Progress of overall tunnel design toward the basic design

H. Hayano KEK

CFS design flow, currently on-going

Simplified Damping Ring Tunnel

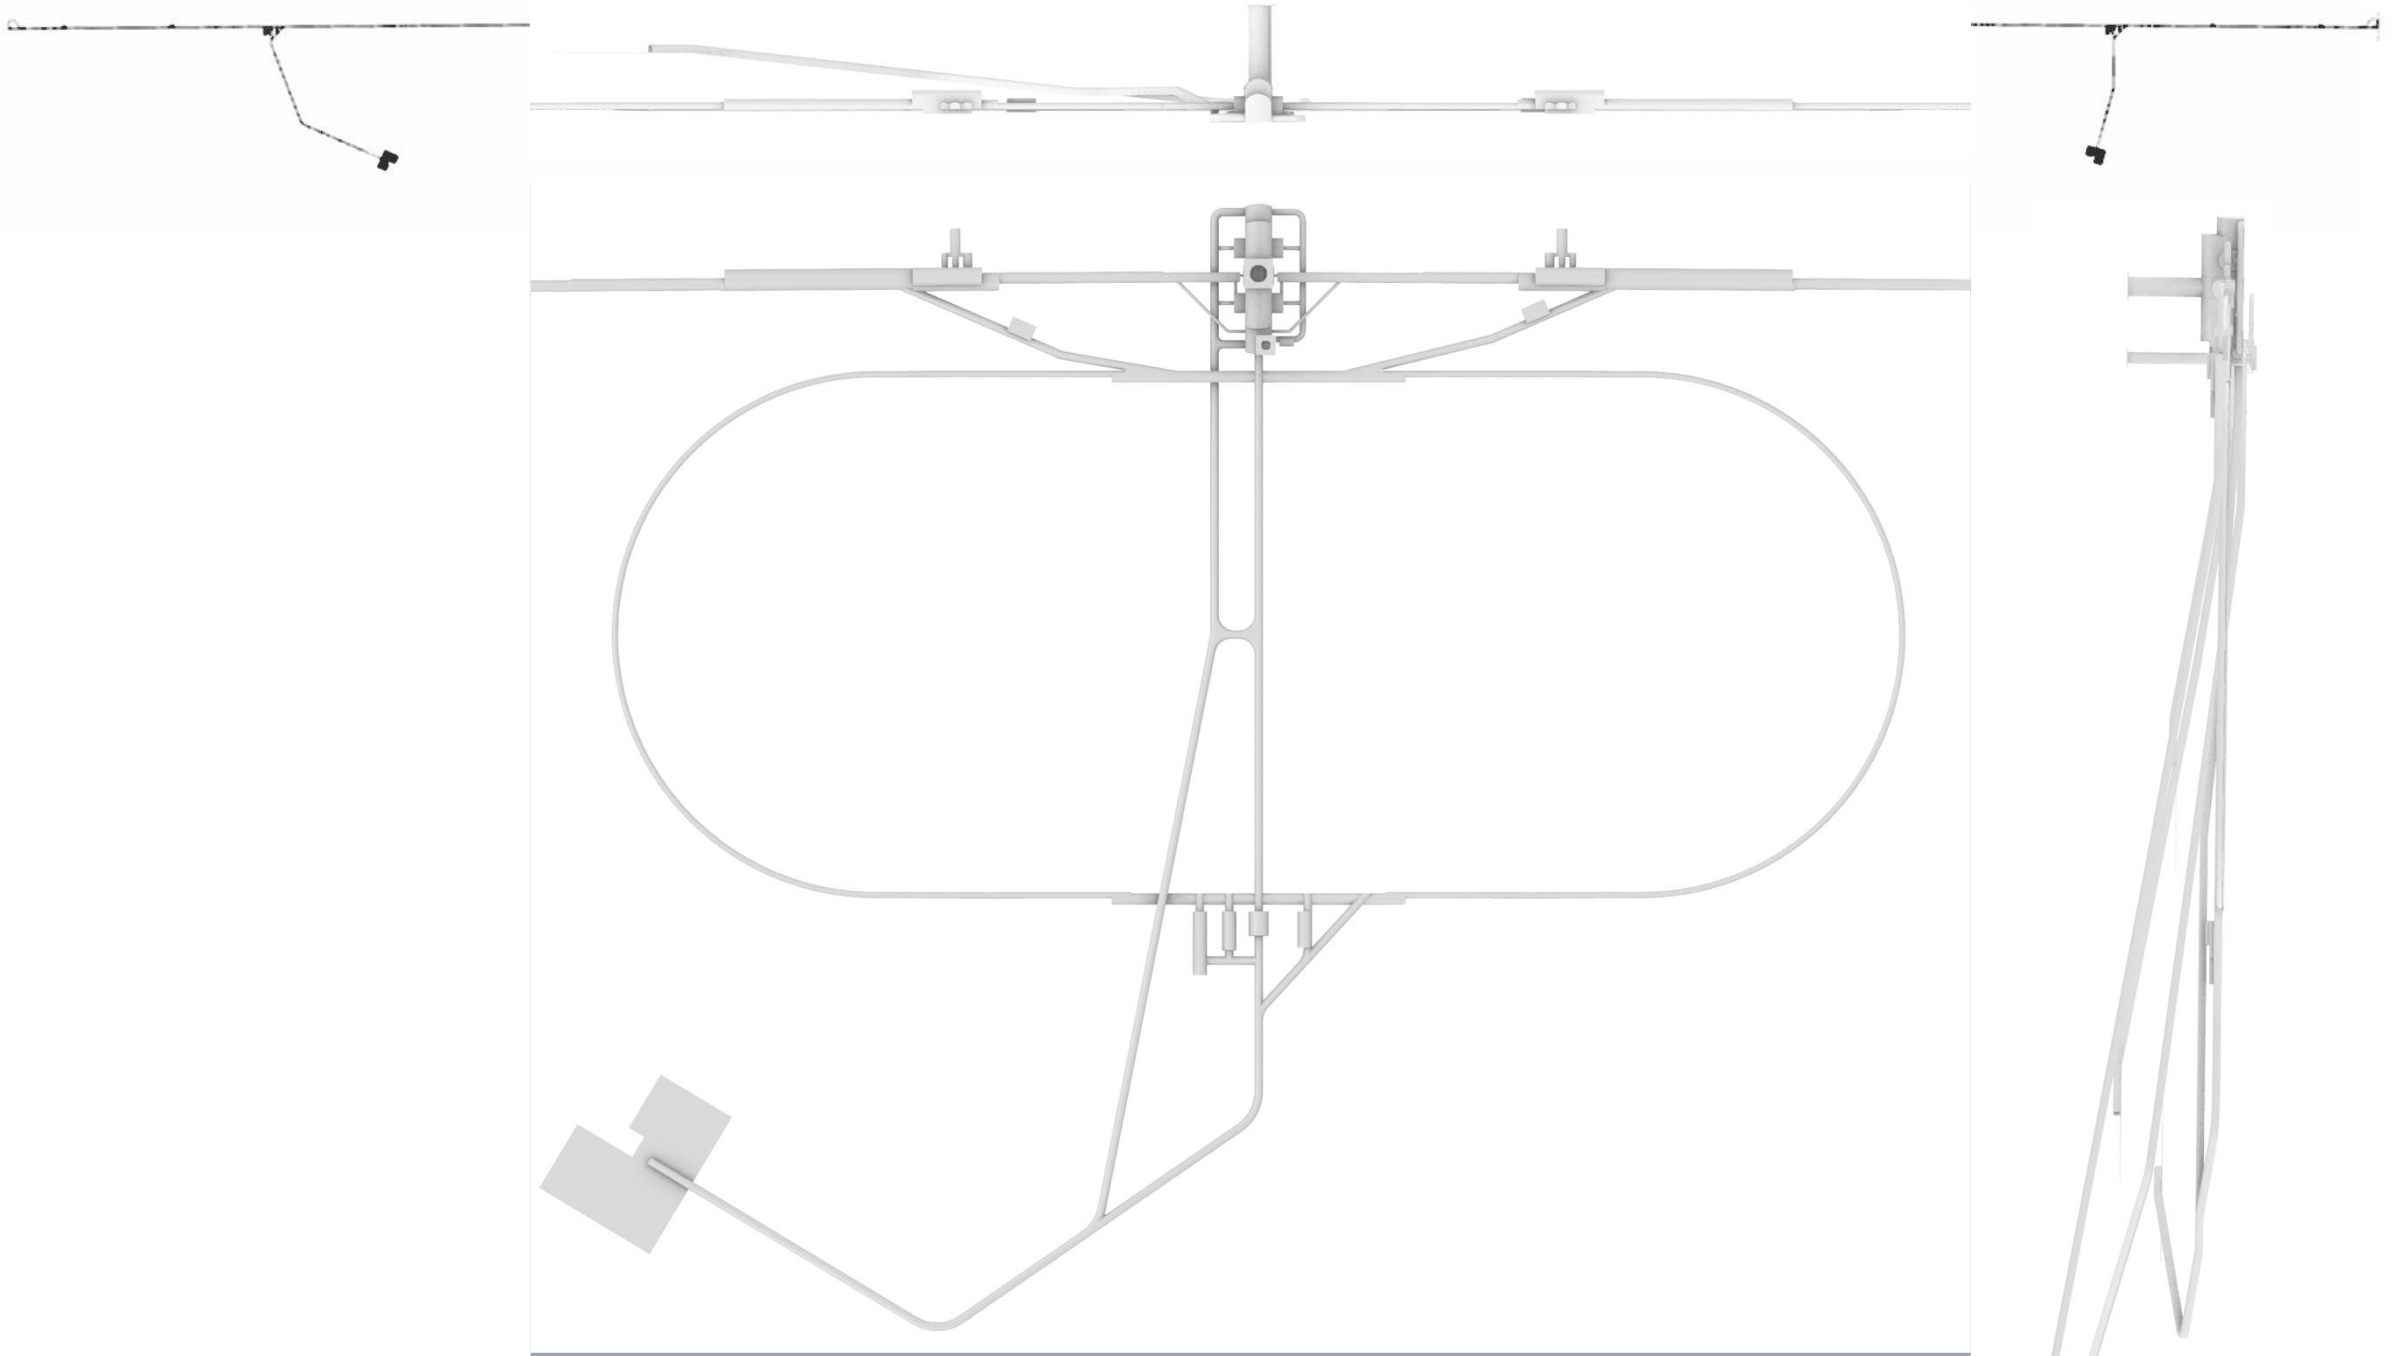
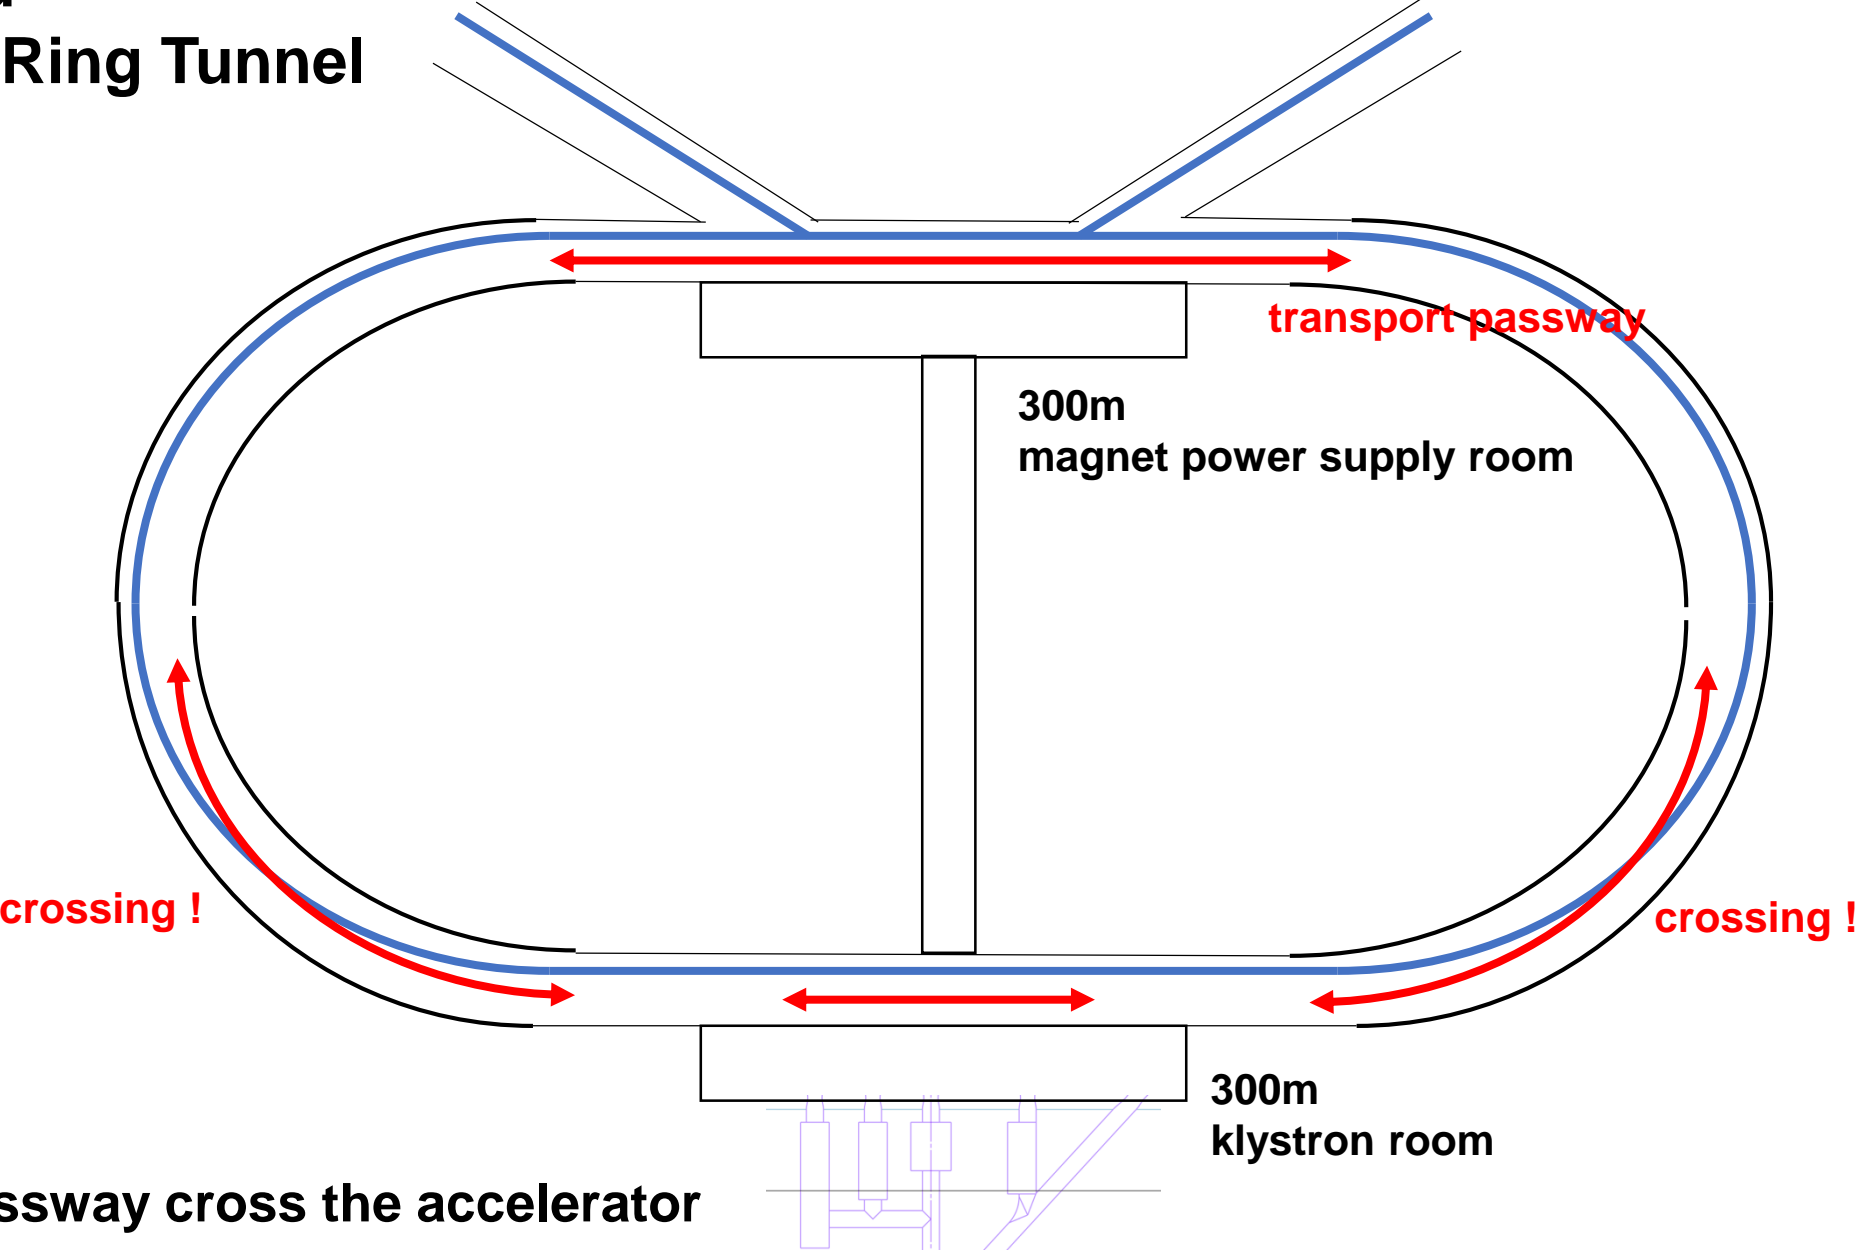
12)Current damping ring tunnel design require crossing of maintenance root with accelerator. Need to change the access hall location.
